# Groundwater Application Review Summary Form

Application # G- 18912

GW Reviewer Phil Marcy Date Review Completed: 04/03/2020

**SUBJECT: Scenic Waterway Interference Evaluation**

Water-Level Trends in Nearby Wells

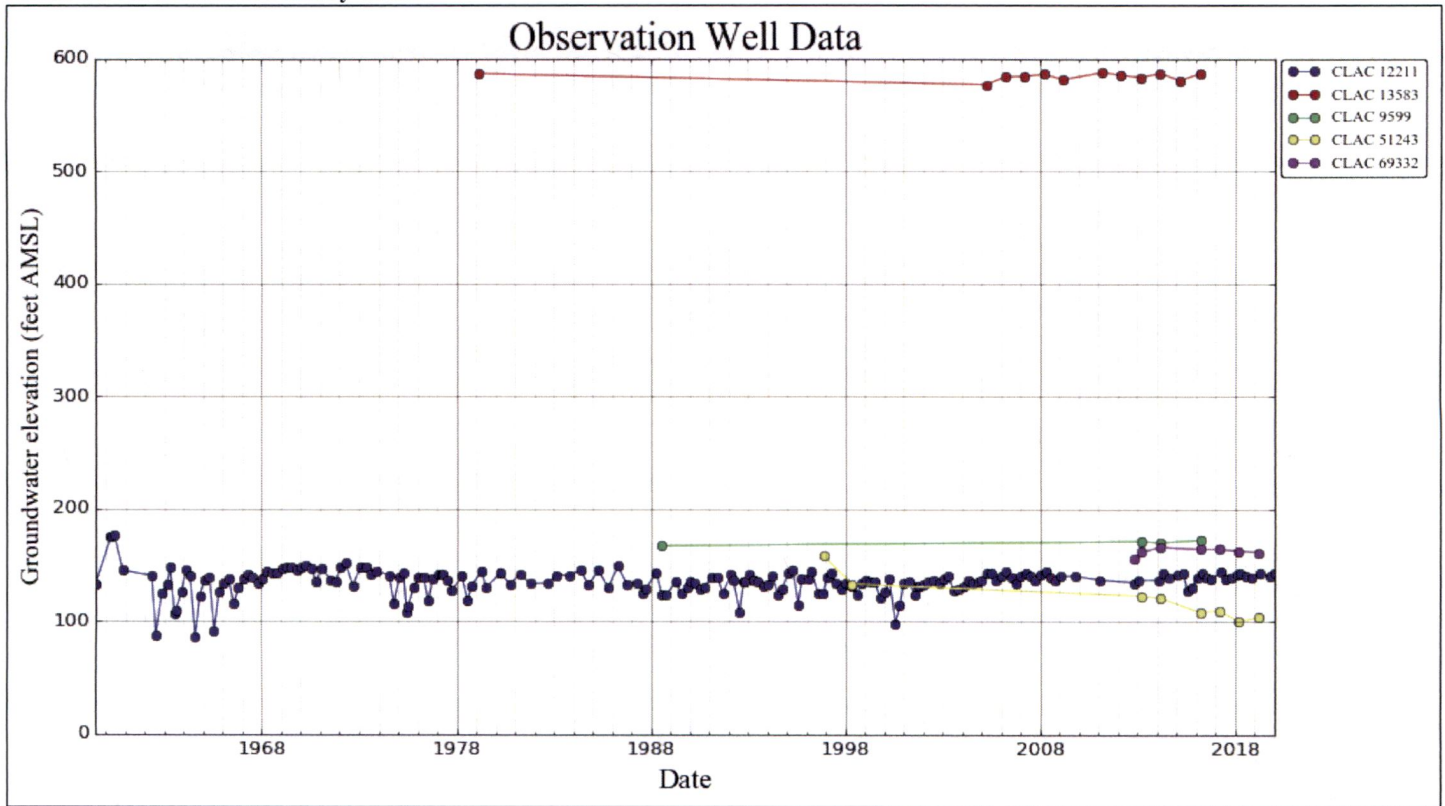
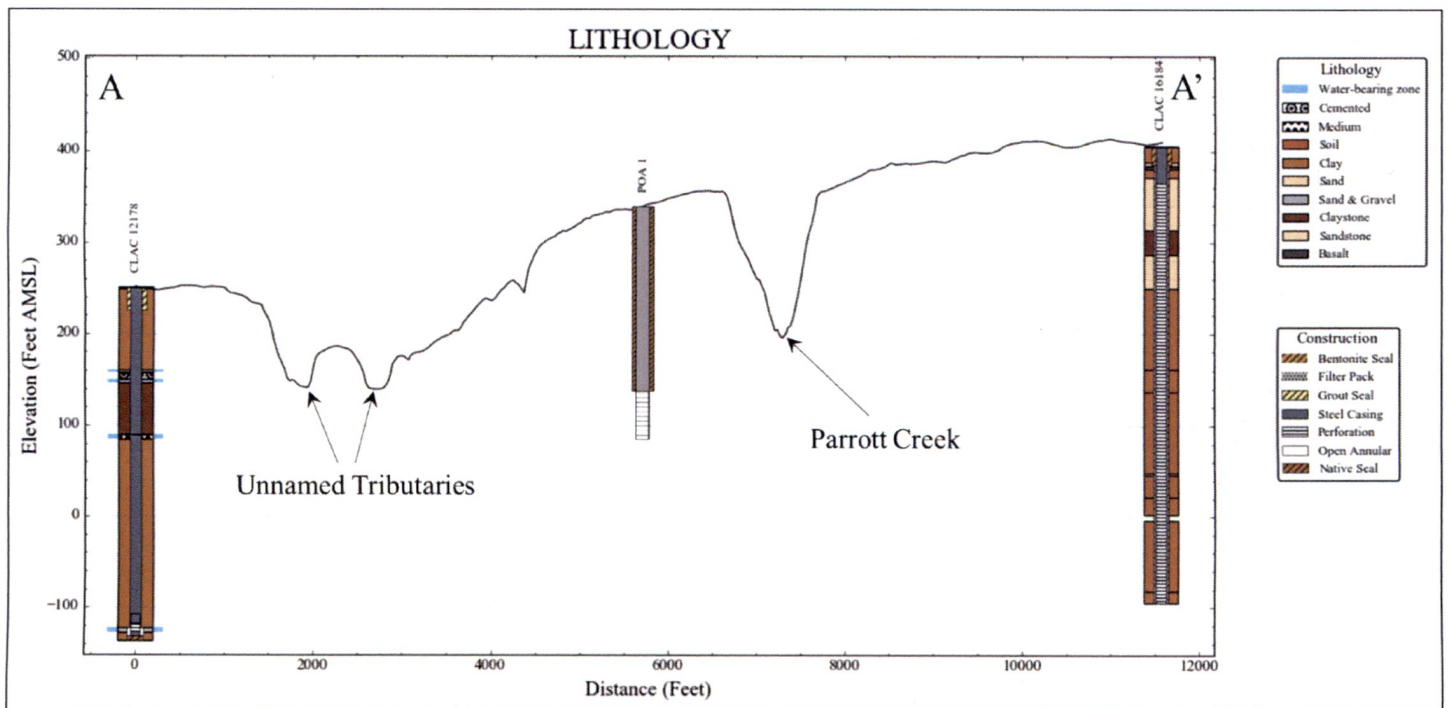
Water level data from nearby wells display reasonably stable water levels. Color symbols are shown on location map.

Water-bearing zones accessed by most nearby wells, and the proposed POA wells, are at elevations coincident with the range of elevations of nearby incised drainages. Production from these wells in the Lower Troutdale/Sandy River Mudstone sequence is limited to fairly thin horizons of sands and gravels within thick sequences of mudstone.
